Amendments to the Drawings:

REMARKS

Appl. No. 10/632,238 Amendment and Response dated August 24, 2004 Reply to Office action of May 25, 2004

Serial No.: 10/632,238 Conf. No.: 2542 Atty Docket No.: PTK-227

FIG. 12

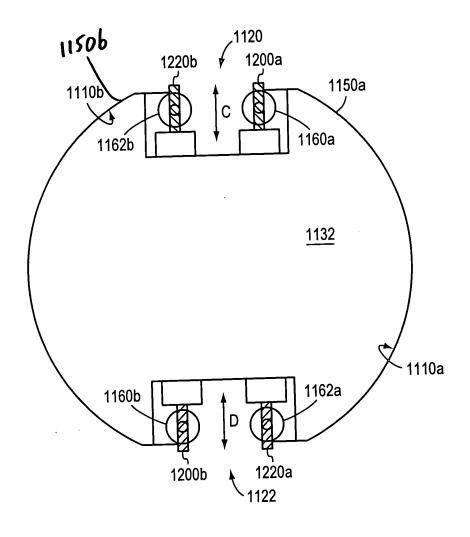
The drawings attached in the Appendix include changes to FIG. 12. Replacement sheet 11, which includes FIG. 12, replaces the original sheet 11 including FIG. 12. In FIG. 12, previously omitted element 1150b has been added.

Applicants have also amended FIG. 12 to add previously omitted reference numeral "1150b." Support of the drawing amendment is found, for example, on page 19, paragraph 73.
